CITY OF MADISON

PLAN OF PROPOSED IMPROVEMENT

N FRANKLIN AVENUE & LYNN TERRACE - ASSESSMENT DISTRICT 2025

CITY PROJECT NO. 15113
CONTRACT NO. 8766

15113		MADISON, WI		8766	
N FRANKLIN AVE - WATER PLAN & PROFILE		N FRANKLIN AVENUE & LYNN TERRACE - ASSESSMENT DISTRICT 2025		CONTRACT NO:	
15113		W-3			
M:\DESIGN\Projects\15113\CAD\Water\15113WU-Water Franklin.dwg					
15113		W-3

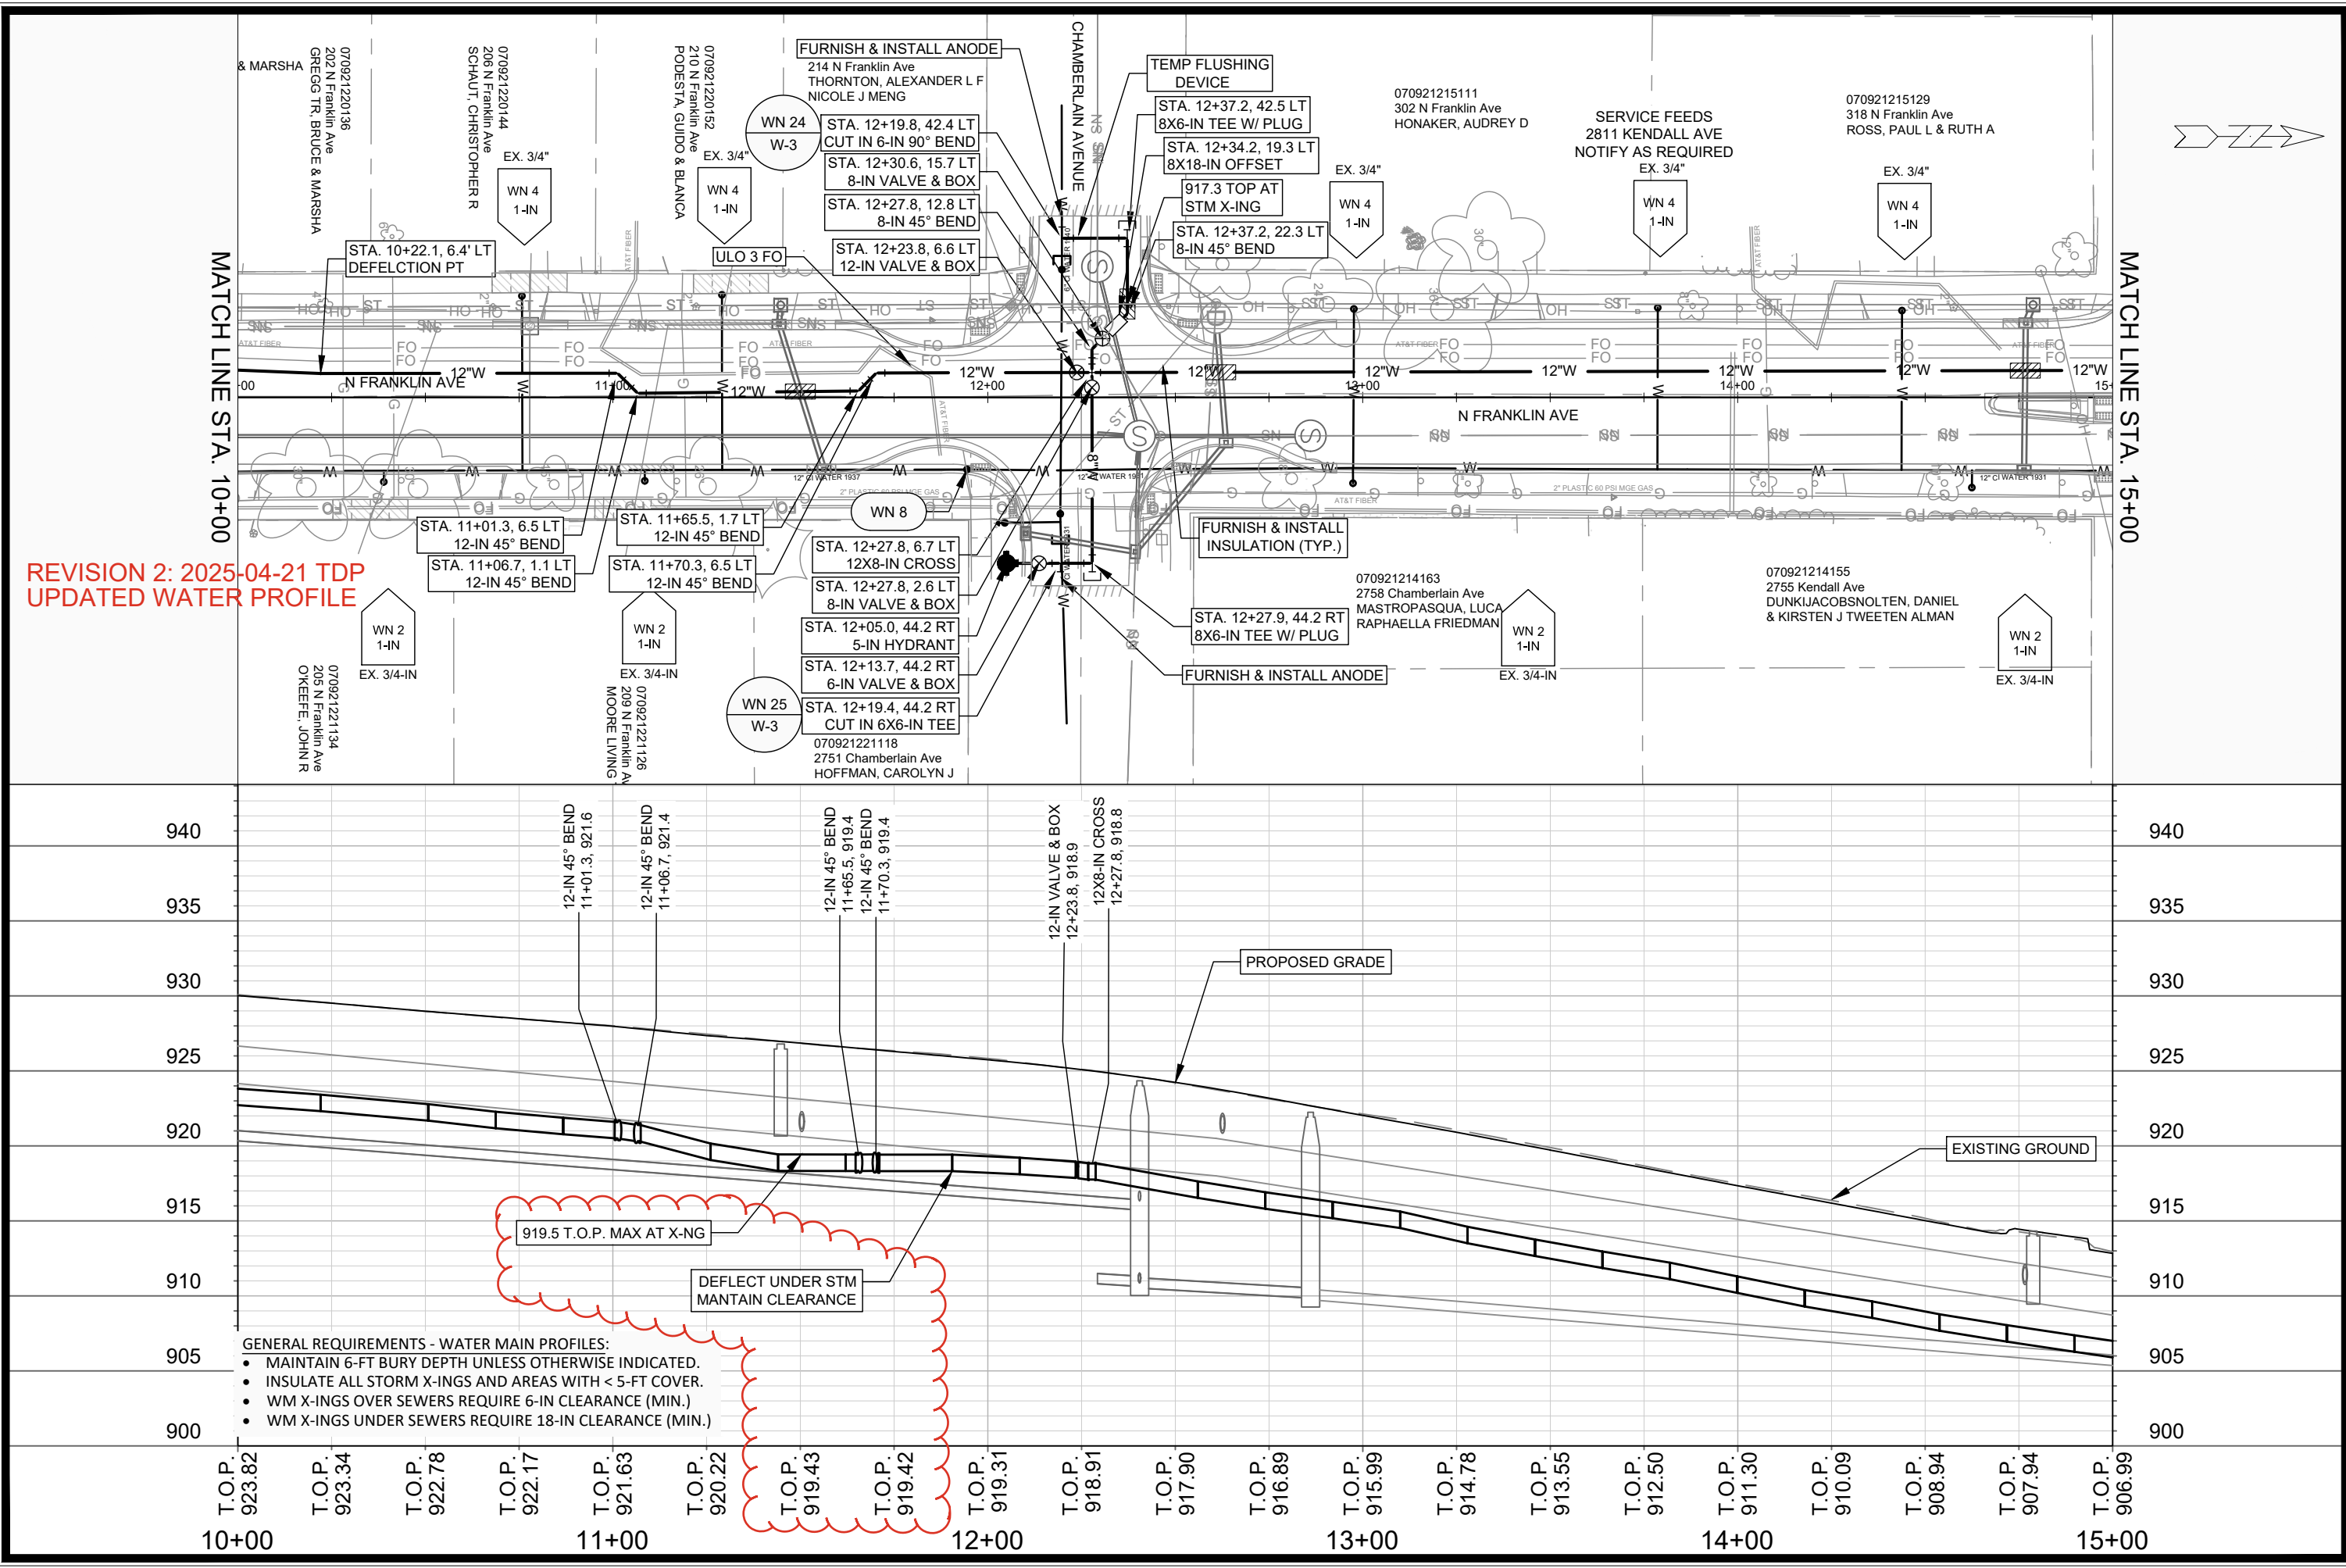
REVISION 2: 2025-04-21 TDP
UPDATED WATER PROFILE
